UNITED STATES PATENT AND TRADEMARK OFFICE

Office Action Summary	Application No. 10/068,670	Applicant(s) EHWALD ET AL.	
	Examiner Manuel Mendez	Art Unit 3763

DETAILED ACTION

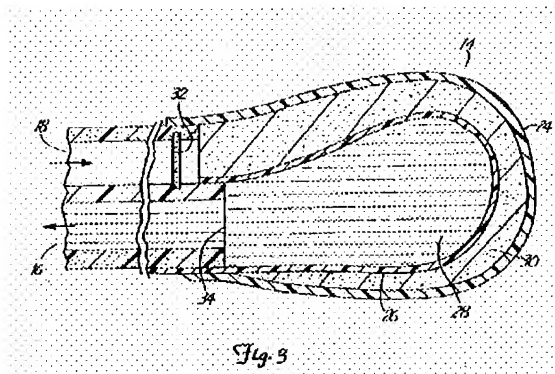
Claims 28, 46, and 61 are rejected under 35 U.S.C. 102(e) as being anticipated by Odland. The Odland Patent shows in figure 3 below, a probe comprising a proximal probe opening providing access to a supply line and a drainage line; a distal probe tip for introducing the probe into subcutaneous tissue, a supply line for introducing drip-feed solution into the probe, a drainage line; a dialysis section being formed between the supply line and the drainage line; the drip-feed solution flowing through the supply line in a flow direction, the flow direction being reversed in the area of the dialysis section and between the supply line and the drainage line.
